Docket Number:	25-IEPR-01
Project Title:	General Scope
TN #:	270024
Document Title:	San José Clean Energy Comments - San José Clean Energy Comments on the Draft 2025 Integrated Energy Policy Report
Description:	N/A
Filer:	System
Organization:	San José Clean Energy
Submitter Role:	Public Agency
Submission Date:	5/15/2026 4:51:19 PM
Docketed Date:	5/15/2026

San JosÃ© Clean Energy Comments on the Draft 2025 Integrated Energy Policy Report

Subject: 25-IEPR-01 Draft 2025 IEPR

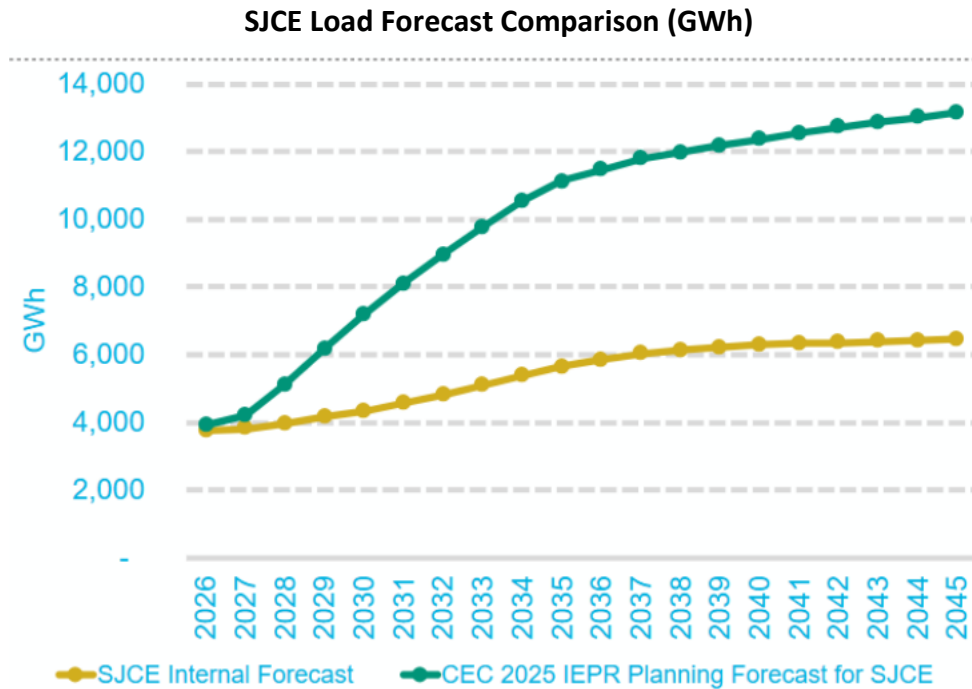
SJCE is operated by the City of San José’s Energy Department. As a city department program, SJCE has provided to the Commission local insights to help inform the IEPR process, insights based on information from other city departments (Department of Planning, Building and Code Enforcement, and Office of Economic Development) and direct engagement with prospective customers. These same insights and prospective customer data also inform SJCE’s own forecasting. As the graph below indicates, SJCE’s internal

forecast materially diverges from the 2025 IEPR Planning Forecast, highlighting the procurement concerns during times of load uncertainty.
